E8361A-10A S E R V I C E N O T E

E8361A PNA Series RF Network Analyzers

Add-on mechanical components to enhance instrument reliability This optional modification is chargeable to customer warranty only if done concurrently with other instrument repairs in an Agilent service facility.

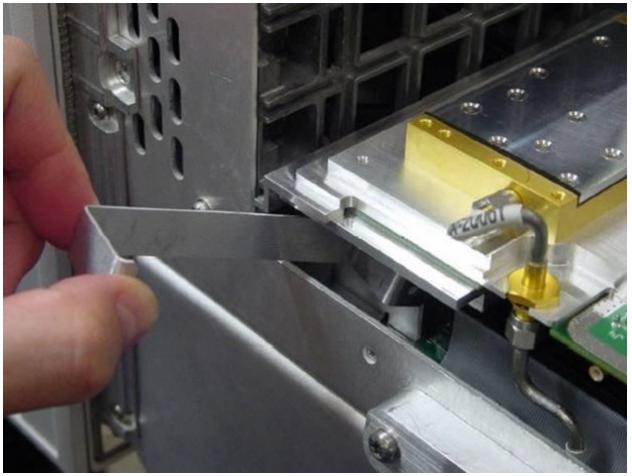
a. Remove and discard existing screw near ribbon cable connector on System Motherboard. See below.

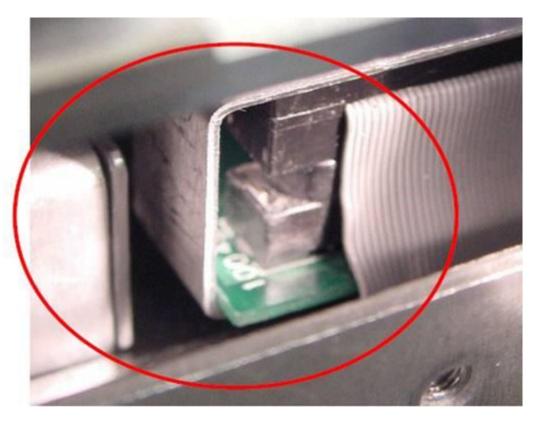
b. Insert Ribbon Cable Clamp under Source Assembly as shown.

c. Position the clamp over the Ribbon Connector. Use needle nose pliers if necessary to slide the clamp into place. Ensure that the edge of the clamp is parallel to the connector and not skewed.

NOTE: Ensure that the Clamp Lip is secured BELOW the edge of the System Motherboard

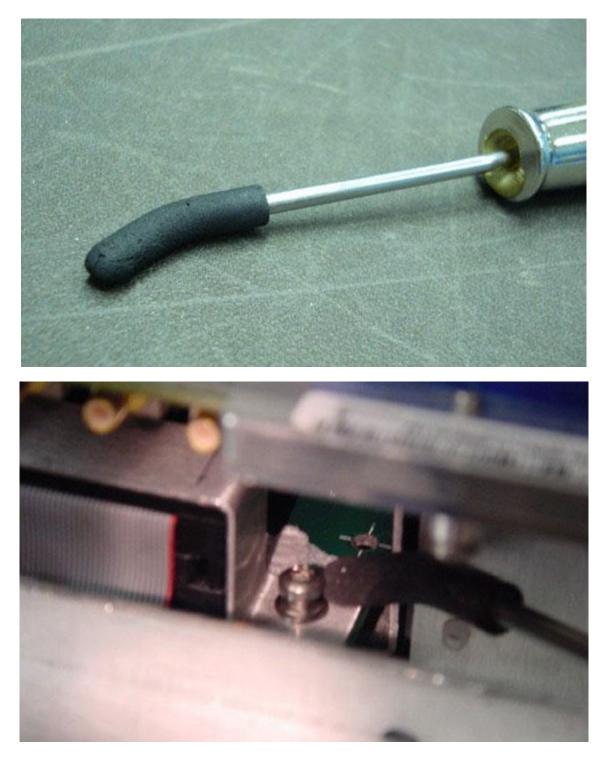
d. Using tweezers, install a new 0515-0374 screw through the hole in the bracket.

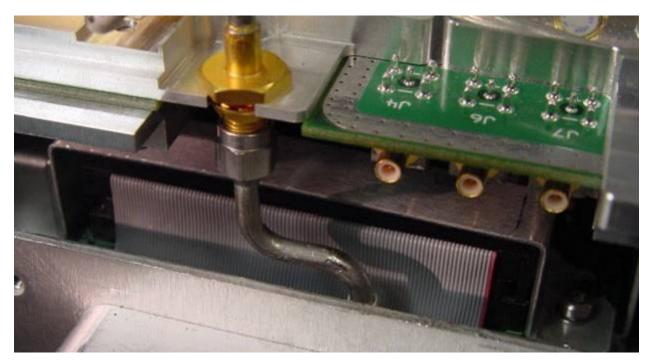
f. Secure screw using the modified 10 lb-in breakaway wrench.

g. This image shows the final position of the secured clamp.

Figure 2b

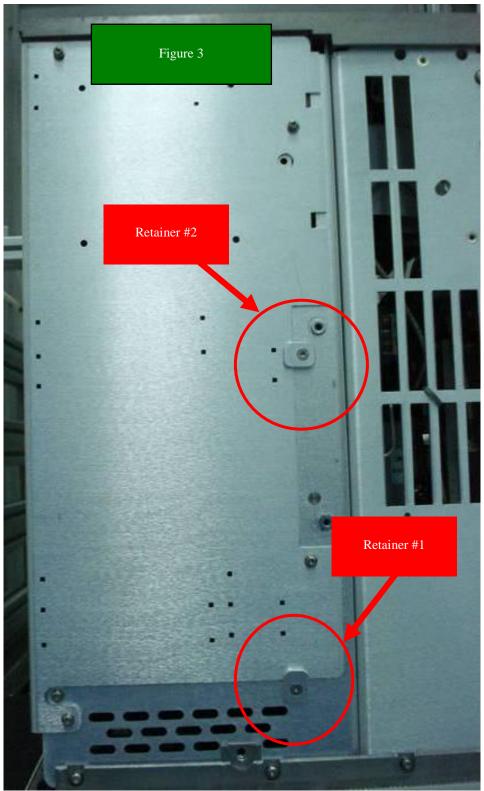
The Clip Retainer (E8361-20067) to be secured with Flat Head screw (0515-1644) in 2 places at 9 lb-in. This Retainer Clip may naturally rotate a bit when being secured, which is acceptable. Note that the existing screw needs to be removed and discarded prior installing Retainer Clip #1 (shown below in Figure 2a, 2b, and 3).
